**WestJumpAQMS
Response to Comments by Air Quality Stakeholder Review**

Document: [Western Regional Air Partnership \(WRAP\) West-wide Jump-start Air Quality Modeling Study \(WestJumpAQMS\) Draft Final Modeling Protocol dated October 19, 2012](http://www.wrapair2.org/pdf/WestJumpAQMS_Modeling_Protocol_and_SourceApportionment_Design_Draft_Final.pdf)

Response-to-Comments Dated May 1, 2013

Figure 1. Updated 4 km DSAD domain.

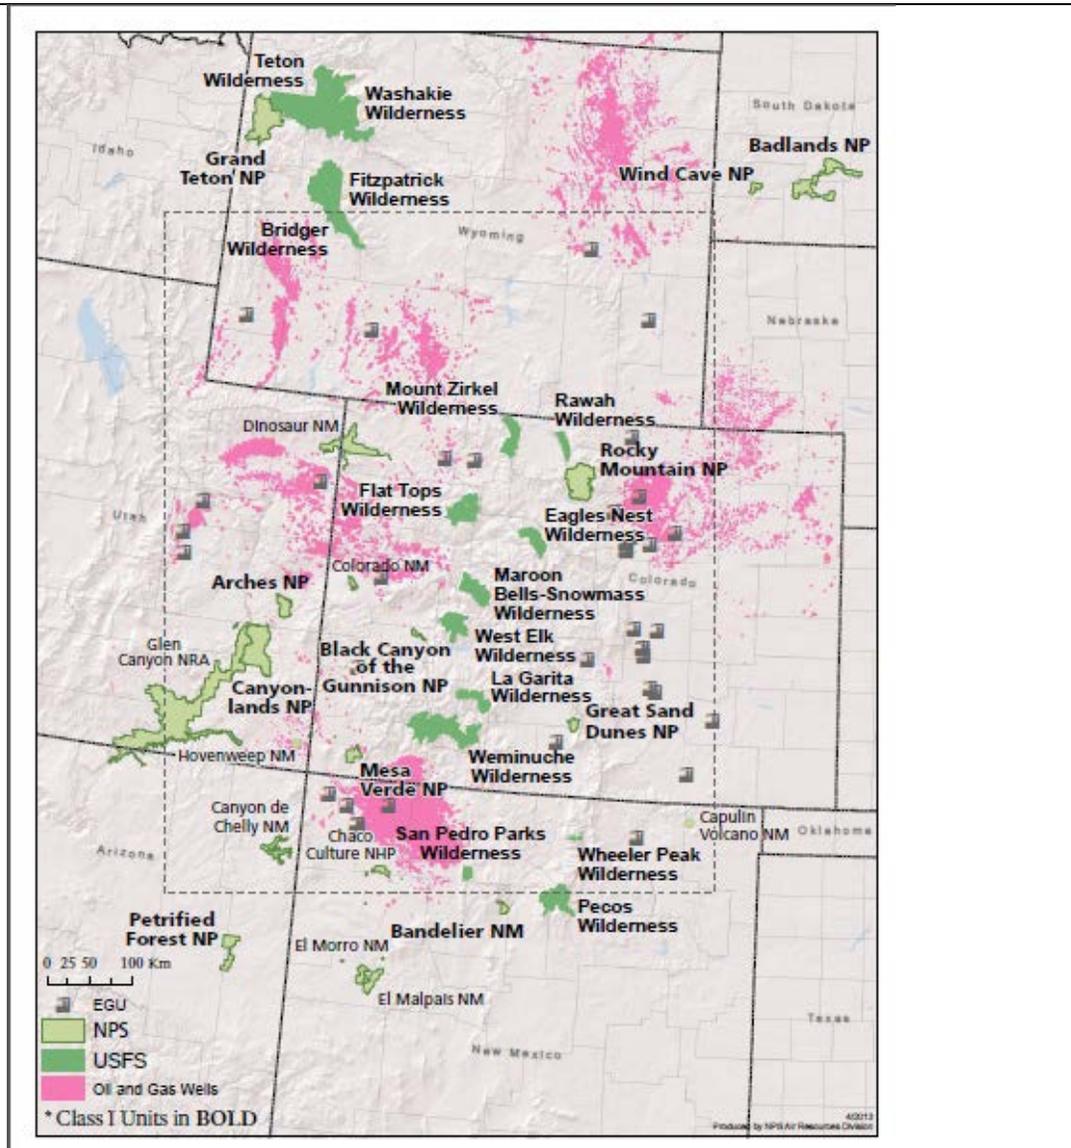
2	BLM COSO	9.2.9	80	Further, I would hope the website and reporting tools would be capable of producing or providing detailed emissions data at sub domain/regional scales (if not at the SMOKE/PGM grid scale). Emissions data pertaining to source classes and the associated modeled impacts may be useful in analyzing proposed emissions changes (at those scales) from NEPA projects and potentially teasing out any air quality impacts or changes, given the extensive source apportionment and sensitivities analysis that will be conducted for this study.	This is a good idea to add the emissions for the different Source Groups to the on-line tool so emissions displays can be generated and emissions data can be extracted from the tool.
Comments from Bureau of Land Management Utah State Office, Leonard Herr, Received 11/20/12					
1	BLM UTSO	4.1.2	29	BLM Utah would like to use the DSAD for the North and South San Juan Basins to analyze source contributions in two Class I areas in southeast Utah: Canyonlands and Arches National Parks. Based on the	The updated 4 km DSAD domain will include the North and South San Juan oil and gas Basins as well as Arches NP.

11	D. Blewitt	4.1.2	27	<p>Figure 4-7 For the Southeast New Mexico (NM_SE) DSAD (Figure 4-8), plot the sources in the Permian Basin.</p>	The updated 4 km DSAD domain does not includes the Permian Basin.
12	D. Blewitt	4.1.2	31	<p>Proposed Denver-Julesburg Basin 4 km DSAD domain I am concerned that both the Rawah and Rocky Mountain Class I Areas are very close to the edge of the proposed 4 kilometer domain and the modeling results may be affected by edge effects.</p>	The updated 4 km DSAD domain alleviates this concern. Since the 4 km DSAD domains are run using two-way grid nesting with the 12 km WESTUS domain, then there are no “edge effects” as seen when using one-way grid nesting or using other models (e.g., CALPUFF and MM5/WRF).
13	D. Blewitt	4.2	33	Please provide additional discussion regarding the sensitivity testing regarding collapsing of vertical layers in Wyoming. This testing should be factored into the decision regarding level collapsing. The Wyoming example is important because it pertains to a rural environment compared to the urban setting for Denver.	The Wyoming layer collapsing sensitivity test is a little different case where all the layer collapsing occurred in the upper layers that are mostly above the PBL height rather than also in a couple of the lowest layers as in this case. But this section can be expanded to include the Wyoming example as well as another one that did the same lower layer collapsing as WestJumpAQMS performed as part of the Liberty-Clairton (Pittsburgh) PM _{2.5} SIP modeling.

In the comments concerns were raised that oil and gas development that occurred between the 4 km DSAD domains in the draft Modeling Protocol would not be treated using the 4 km grid resolution and the DSAD domains were missing some oil and gas development areas (e.g., southeast Colorado). We had concerns that use of all of the 4 km DSAD domains in a source apportionment run may require more computation time than available in the schedule. Thus instead of running with multiple small 4 km DSAD domains the final Modeling Protocol defines one large DSAD domain that covers the oil and gas development areas in the Southwest Wyoming, Uinta, Piceance, Denver-Julesburg, North San Juan and South San Juan Basins. Figure 1 displays the updated 4 km DSAD.

We have received several written and verbal comments on the definition of the 4 km Detailed Source Apportionment Domains (DSADs) that can be linked to the 36/12 km domains for two-way CAMx simulations and the 4 km Impact Assessment Domains (IADs) that area standalone 4 km CAMx databases that can be used for local air quality impact assessments (e.g., EISs and RMPs). For the IADs, the BLM Colorado State Office and New Mexico State Office has indicated a desire for a 2008 4 km IAD platform that they can use. However, other BLM state offices have not; BLM Utah is pursuing a 2010 modeling platform and BLM Montana/Dakotas has indicated they will look at a 2013 modeling year. Thus, the final Modeling Protocol will document the Colorado and northern New Mexico IAD.
